A.T.S. Apparels Ltd

414, Kouchakuri, Telirchala, Mouchak, Kaliakoir, Gazipur - 1751
(24.01690N, 90.30266E)

25 March 2014

Observations

Column Strength

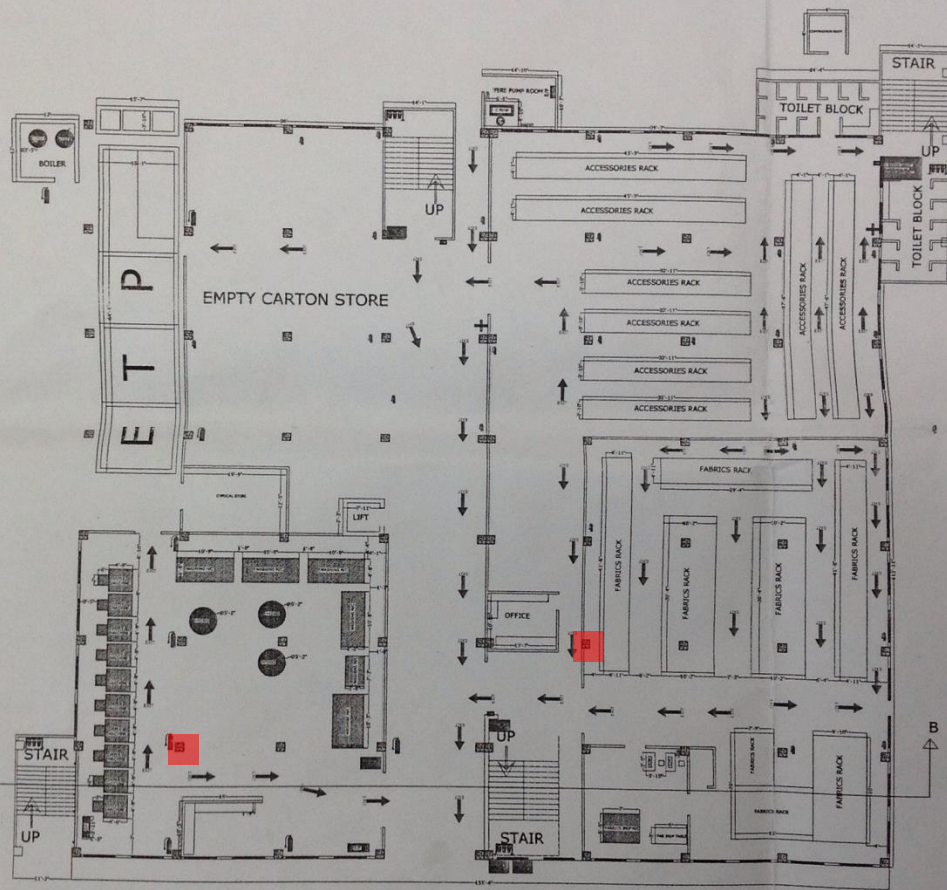
Columns appear to be stressed in excess of normal design limits – Building Engineer to verify concrete stresses and in-situ concrete strength

Cursory calculations indicate that the working stress of columns at Ground Floor level are at a high level.

Building Engineer to check that columns have been designed to accommodate loads.

Roof – Plastic Water Tank

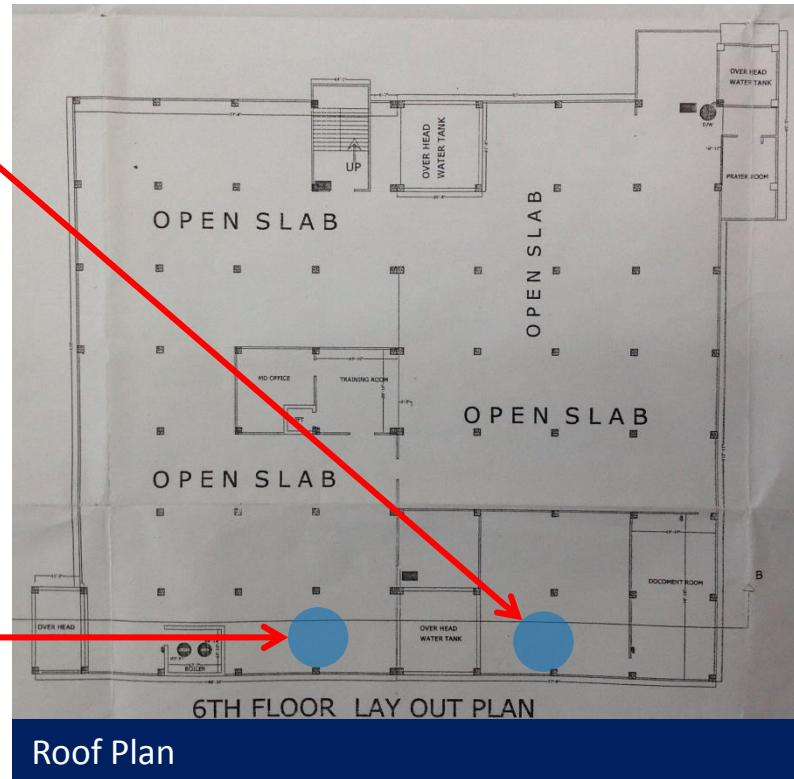
Design Check required for the loading from the plastic water tanks at roof level and for the location of the fusing machine at 3rd Floor Level

2 no. 5000L water tanks, mounted on 100mm brickwork are loading the roof slab structure.

Building Engineer to check that the beams and slabs have been designed to accommodate the loads.

Fusing Machine Area

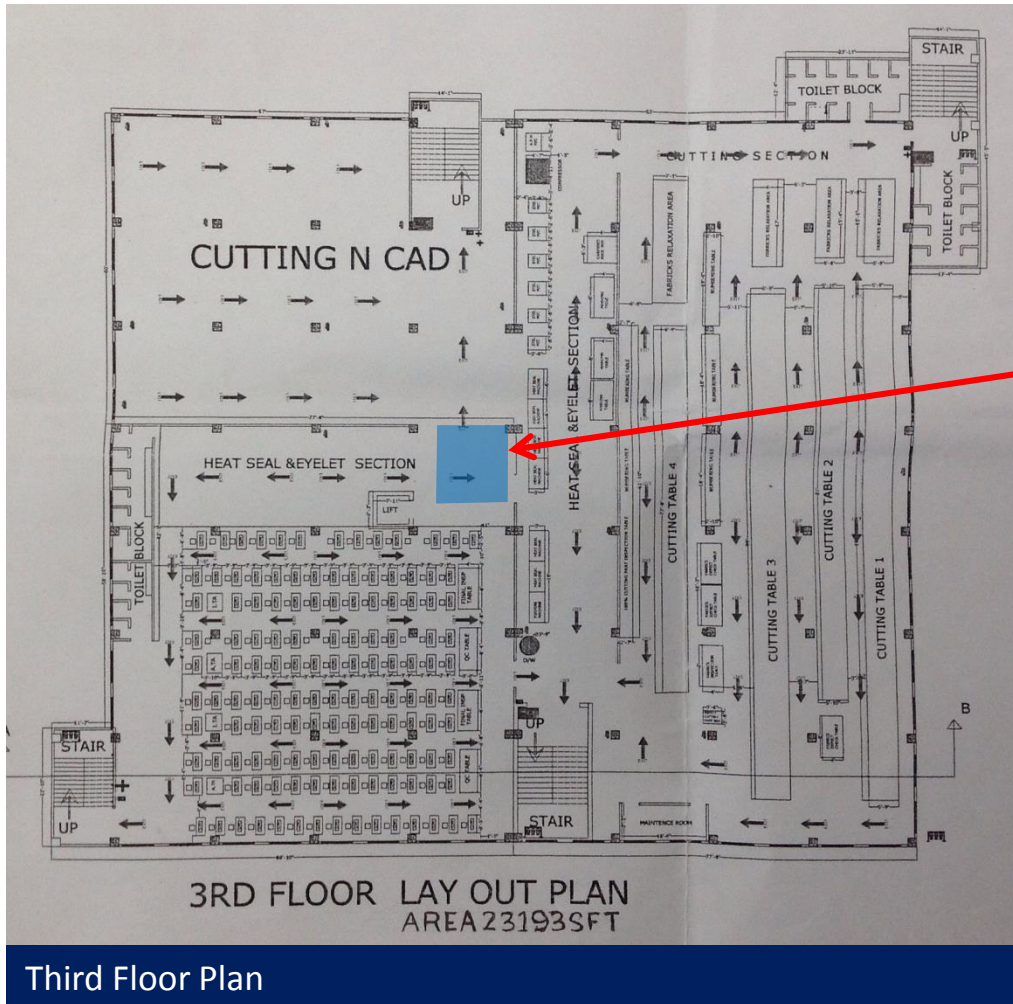
There is a Fusing Machine at Third Floor level adjacent to the movement joint.

Building Engineer to check that the beams and slabs have been adequately designed to carry the associated loading.

Lightweight Steel Structures

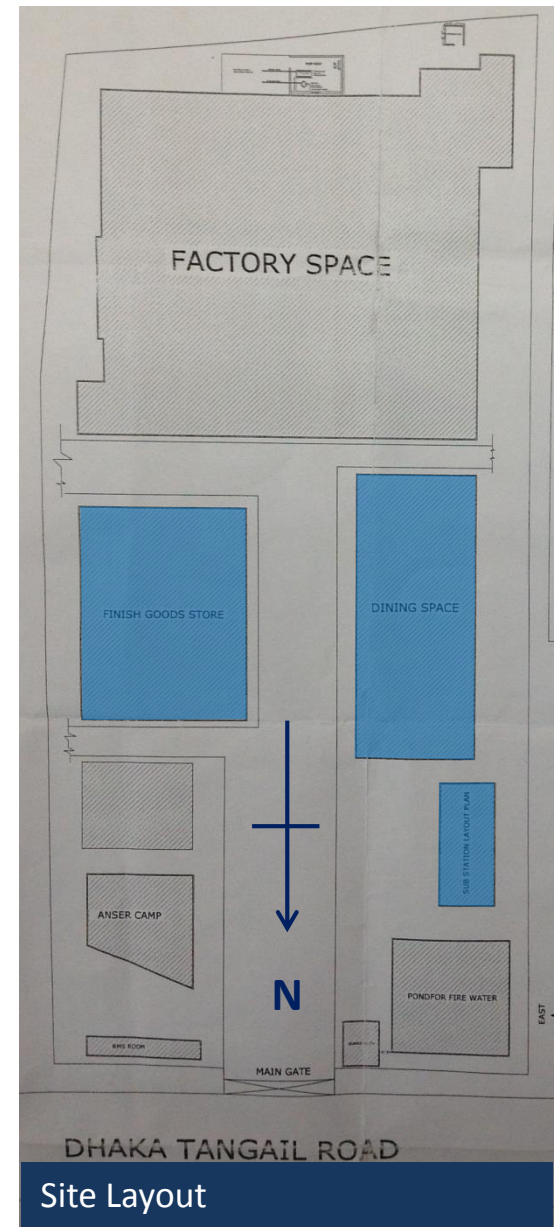
Design check required for the single storey buildings to confirm their adequacy to support wind loading (pressure / suction and uplift)

Capacity of lightweight roof structures for Ancillary buildings to resist uplift loading due to wind to be checked, with particular emphasis on connections and lateral stability.

Fire escape ladders

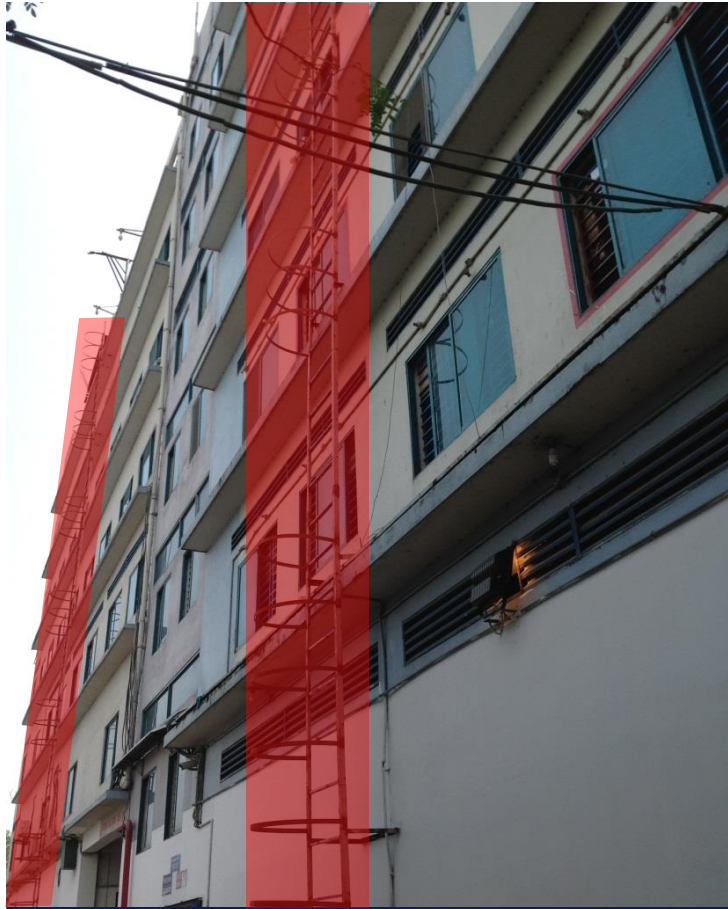
Design check required for the vertical escape ladders on the façades

The vertical fire escape ladders to the building elevations were observed to be under construction at time of survey.

Building engineer to check the design and detailing of the fire escape ladders.

Ponding to Roof

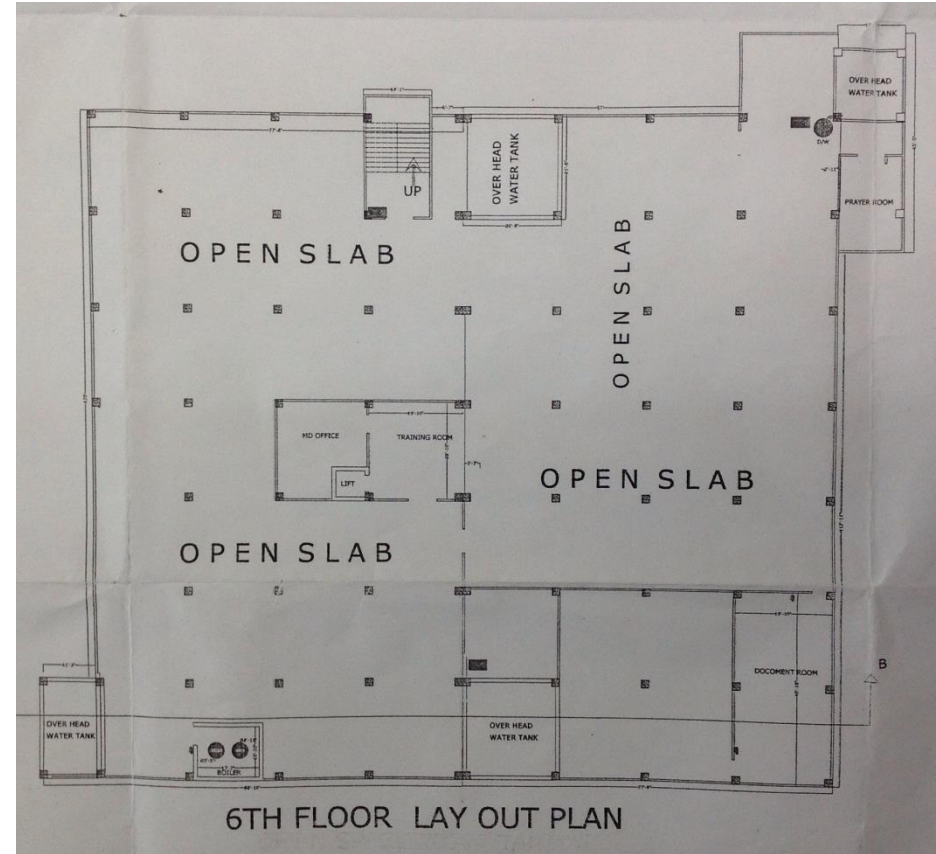
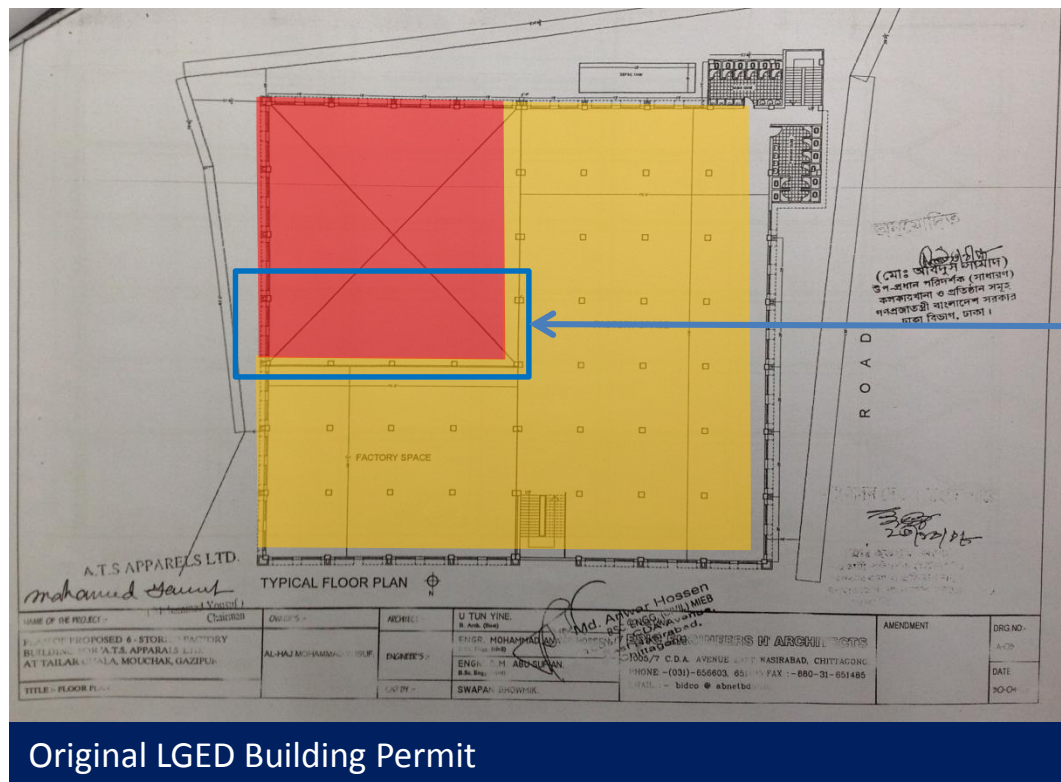
**Roof drainage to be assessed to remove
water ponding**

Building Engineer to assess Roof drainage to remove water ponding.

Permit Inconsistencies

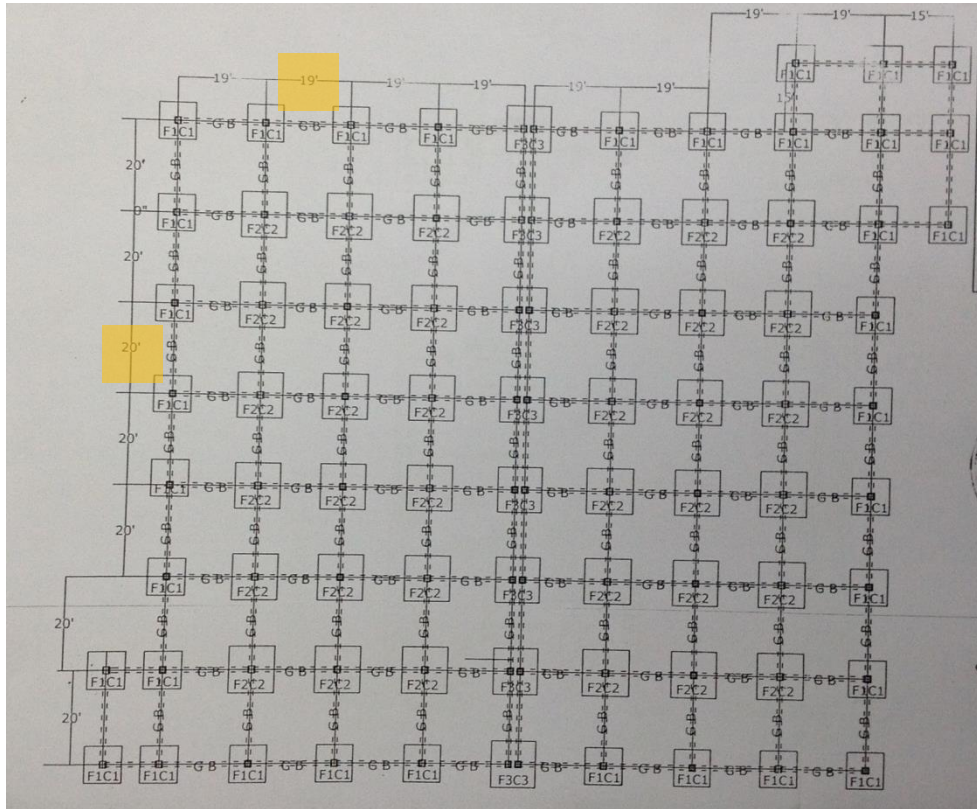
It is noted that an addition to the structure is planned at the South-East corner. Any proposed additions to the existing building structure should be reviewed by the Building Engineer

A 6-storey addition to the structure is planned to the South-East corner of the building, with construction currently underway, for which only an industrial permit (2014) was provided. The original LGED-approved building permit (2006) calls up an L-shaped Factory with a Ground Floor warehouse, as indicated.

Any proposed additions to the existing building structure should be reviewed by the Building Engineer.

Drawing Inconsistencies

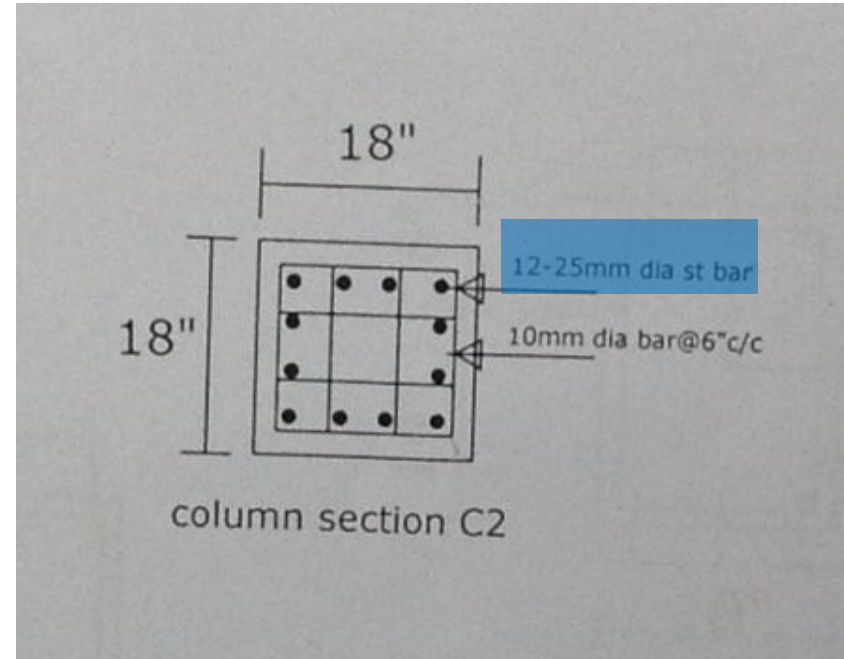
Inconsistencies between the drawings and the constructed building

The structural drawings do not match the current arrangement of the building.

Inconsistency in column layout:

Drawings call up 5.8m x 6.1m (19ft x 20ft), whereas observed grid is 5.3m x 5.6m.

Inconsistency in column rebar:

Drawings call up 12 no. $\varnothing 25\text{mm}$ bars in C2 columns, whereas observed columns have only 10 no. bars (Ferros scanner).

Building engineer to check, collect information and produce accurate and complete as-built documentation.
